**TOWN OF CARMEL
PLANNING BOARD**

**PLANNING BOARD AGENDA
NOVEMBER 12, 2020 – 7:00 P.M.**

Re: Zakon Site Plan
Mike Carnazza 10/21/20 Comments

Re: Zakon Site Plan
Rich Franzetti 10/17/20 Comments

SCALE 1" = 20'
DRAWN AC
JOB 18-010
SHEET
S-1
OF SHEETS

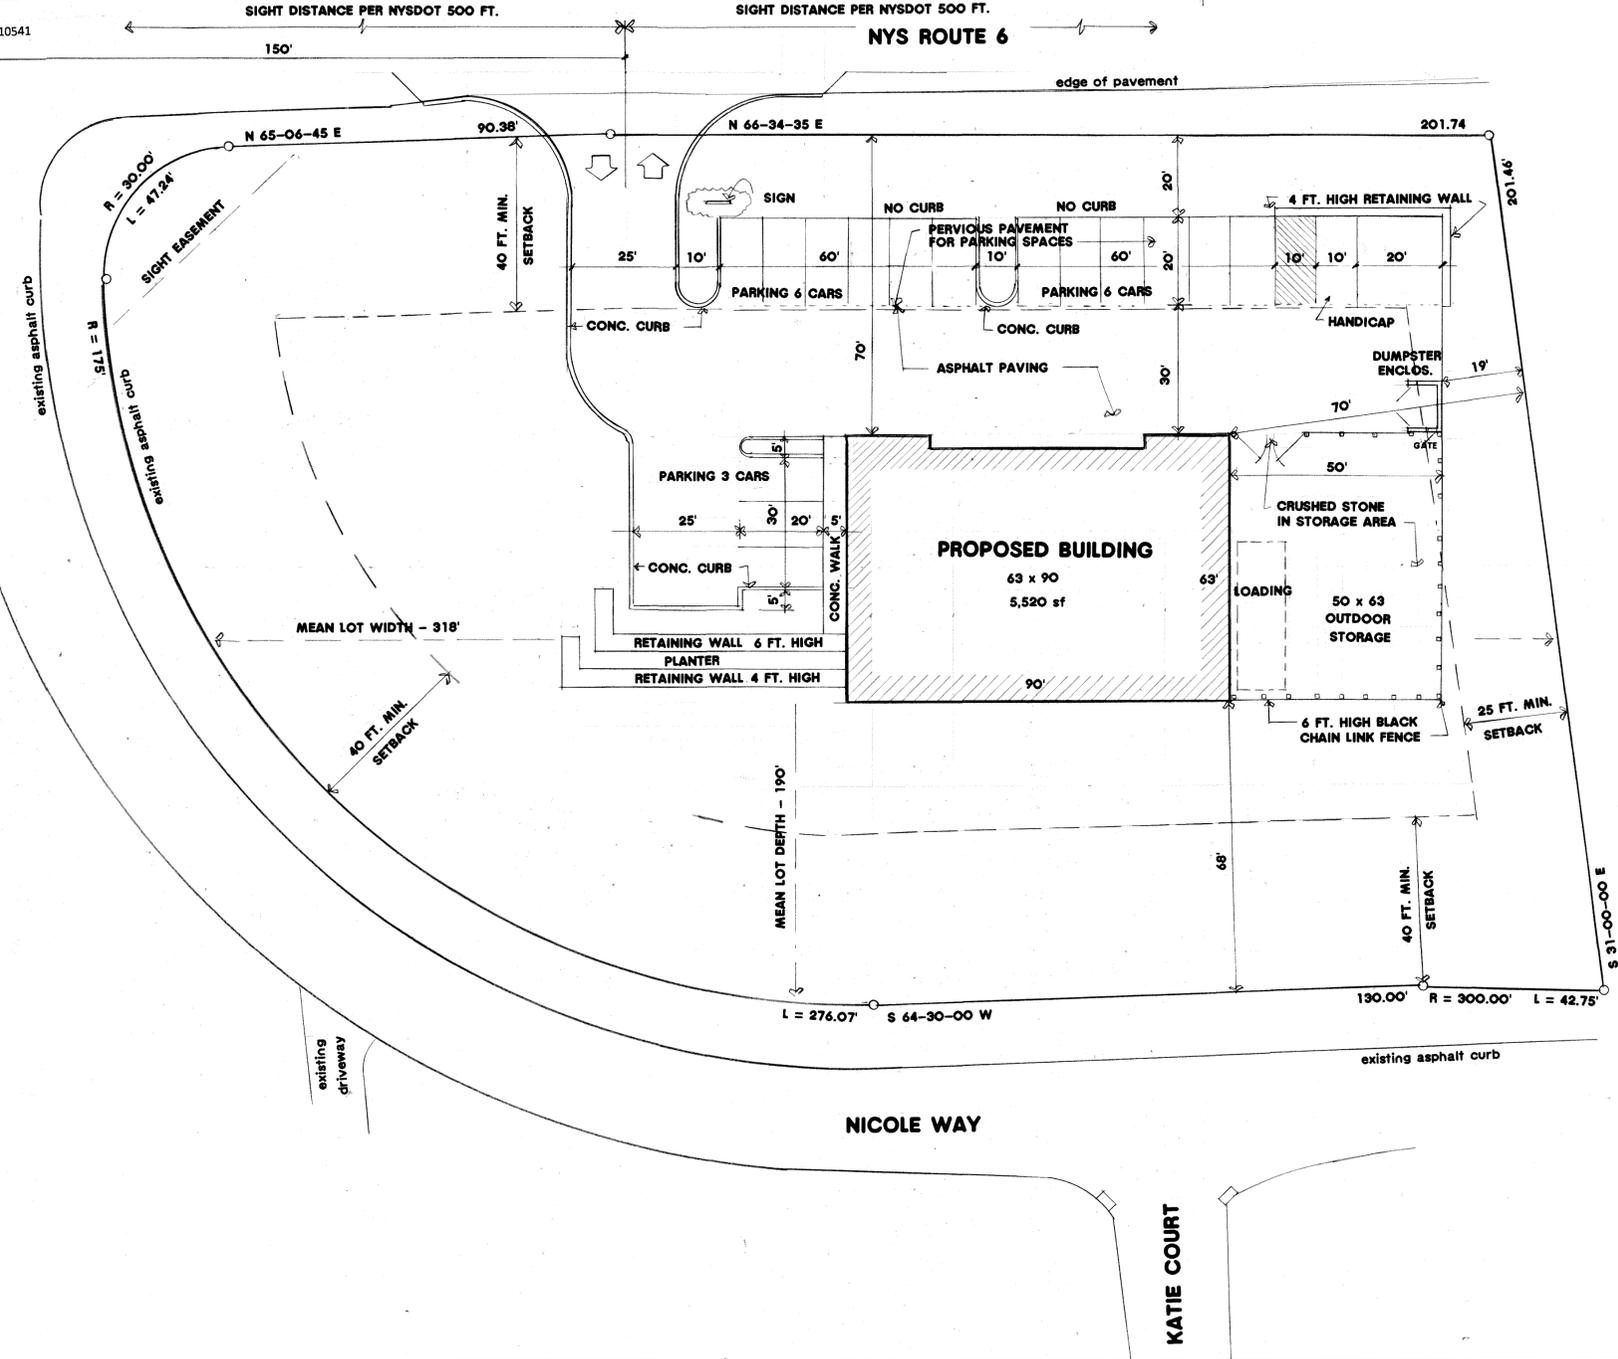
1. Site distances are shown on Sheet S-1. Maser Consulting is currently working w/NYS DOT & the exact amount of clearing that there needs to be to assure appropriate sight distance.
2. Sheet S-4:
 - a. A note has been added that all curbs, sidewalks & asphalt shall meet the T/O Carmel Town code.
 - b. We have increased the thickness of paving as noted.
3. Sheet C-1:

Grading Plan		
SCALE 1" = 20'	DRAWN BY BJW	C-1 1 of 9
DATE 01-25-20	CHECKED BY MAD

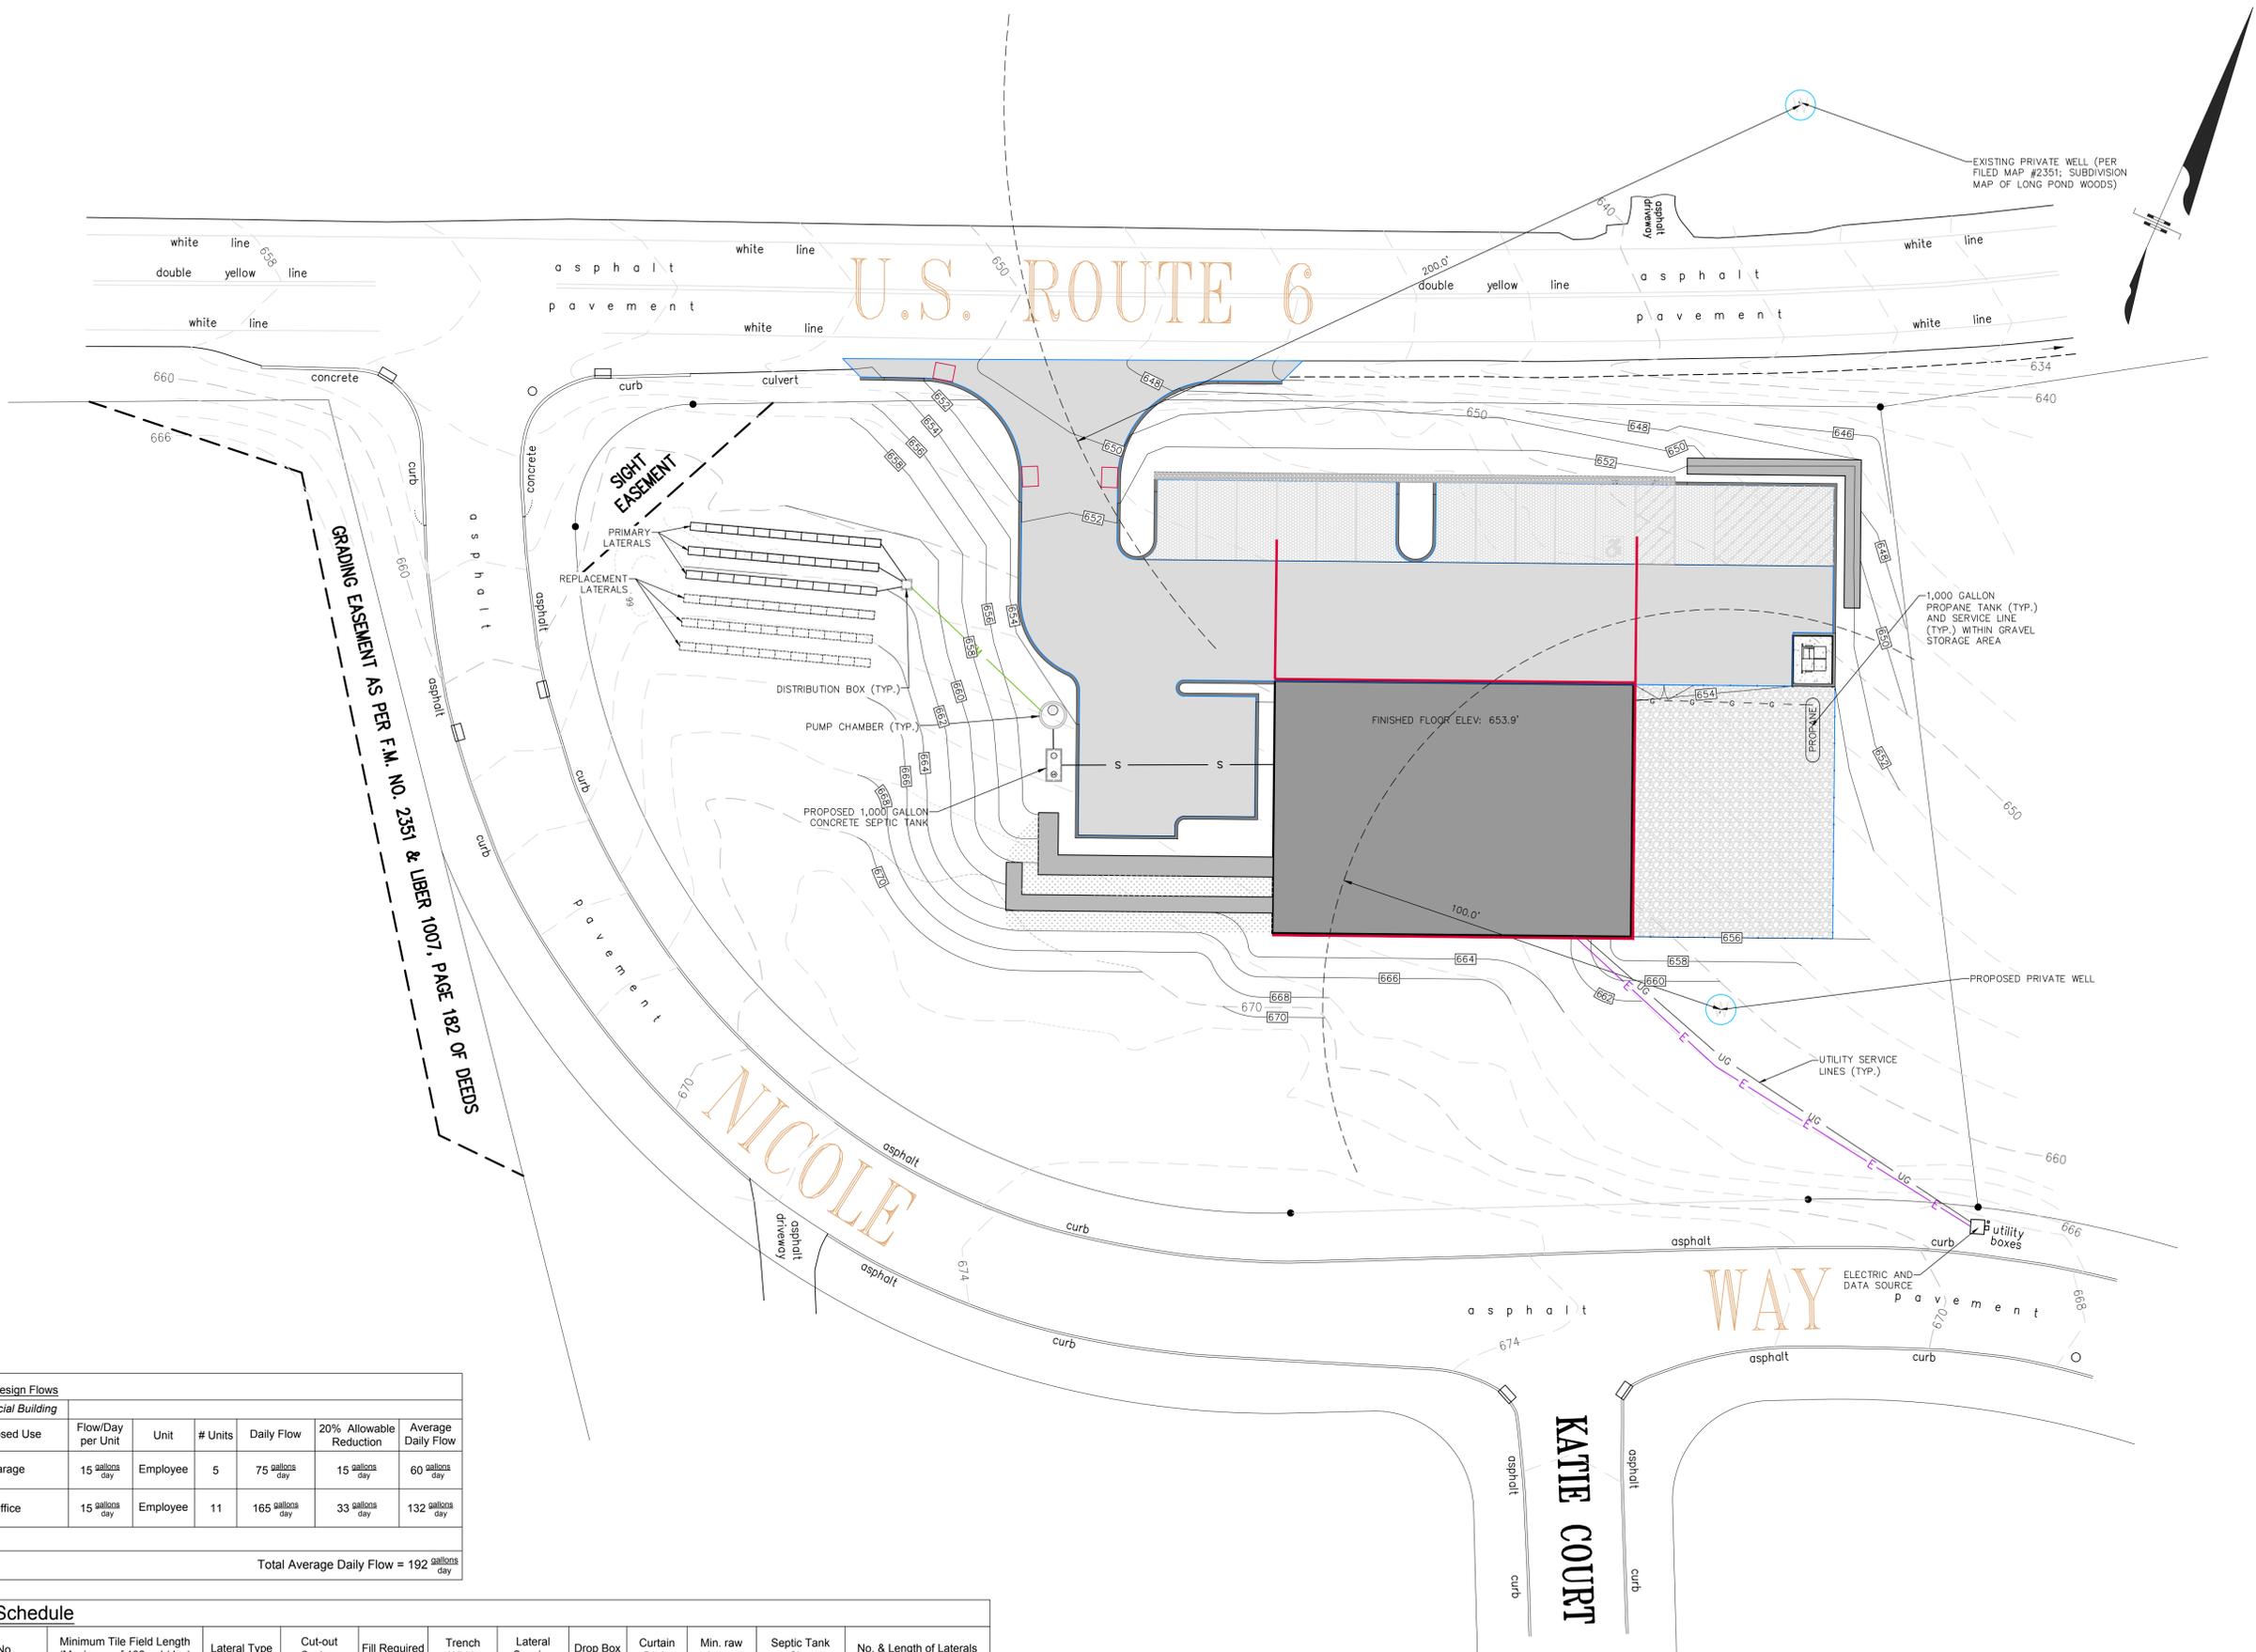
There is currently one retaining wall that is 6 ft. height & will be designed & stamped by a NYSPE prior to construction.
4. Sheet C-2:
 - a. The area for porous pavement has been indicated along with protective measures during construction.

SCALE 1" = 30'	DRAWN BY BJW	DRAWING NO. C-4
DATE 01-25-20	CHECKED BY MAD	4 of 9

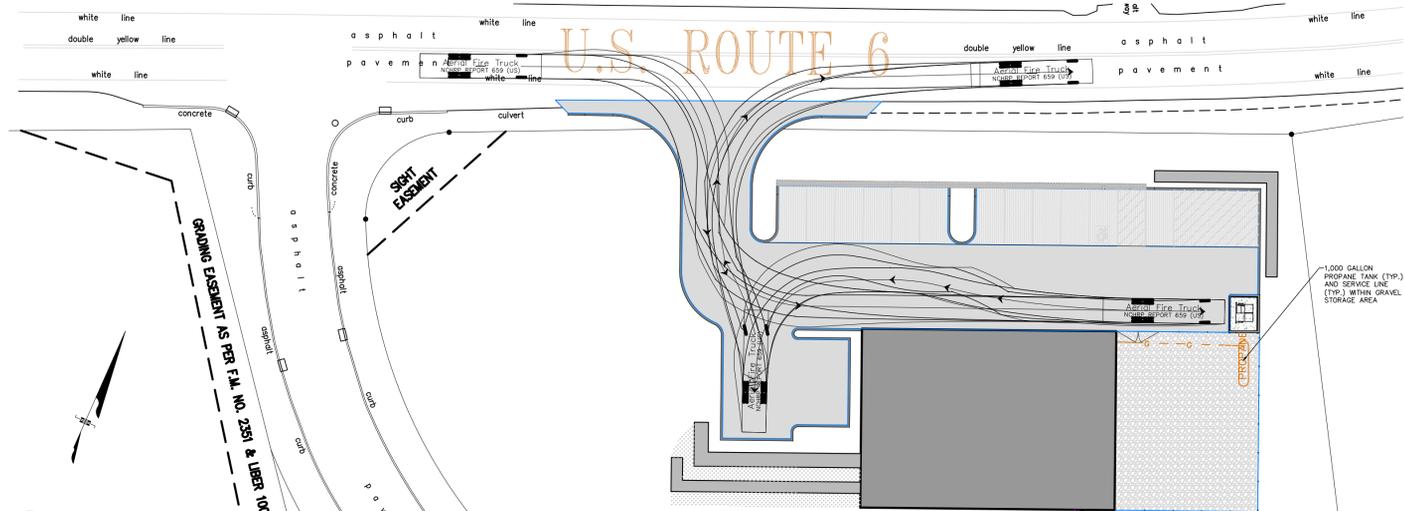
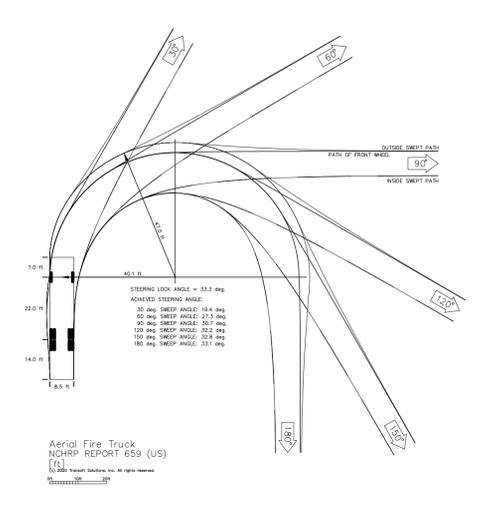
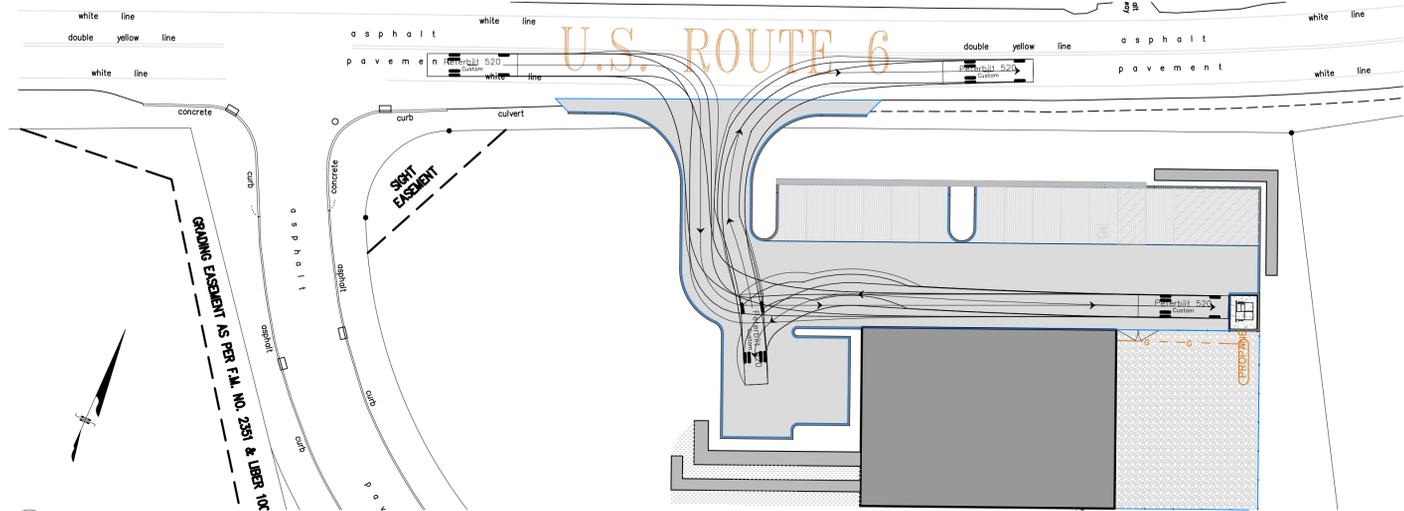
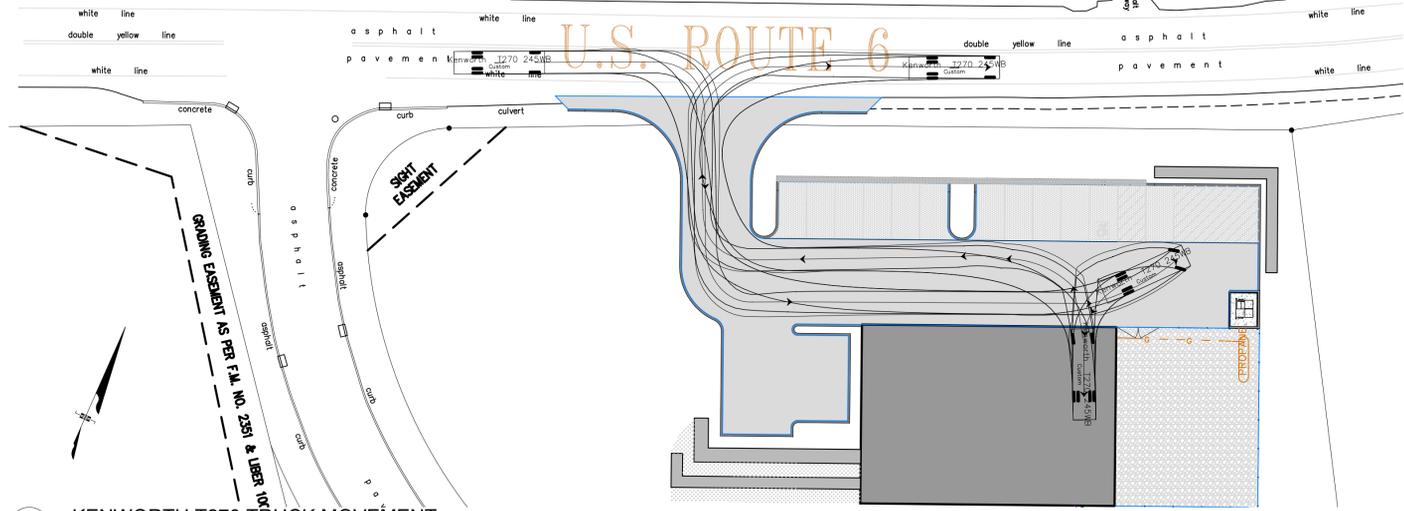
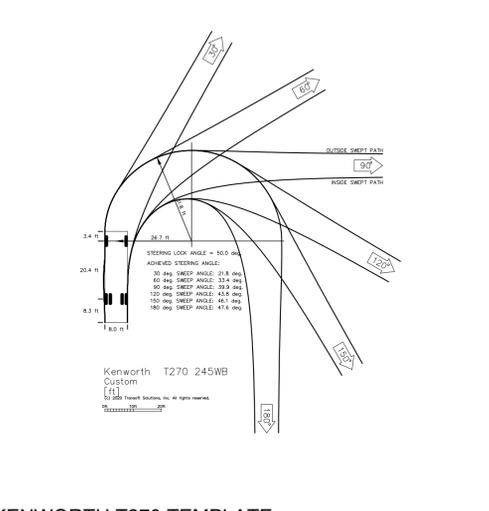
6. Vehicle movement plan (C-4):
 - a. We have added to the vehicle movement plan (C-4) sight distance referencing, as well as on Sheet S-1).
 - b. Pavement markings are now shown on this plan.

- b. The limits of disturbances are now shown on all sheets & should correspond with one another.
5. Sheet C-4: Oil/propane tank movement templates have been added to the drawing.
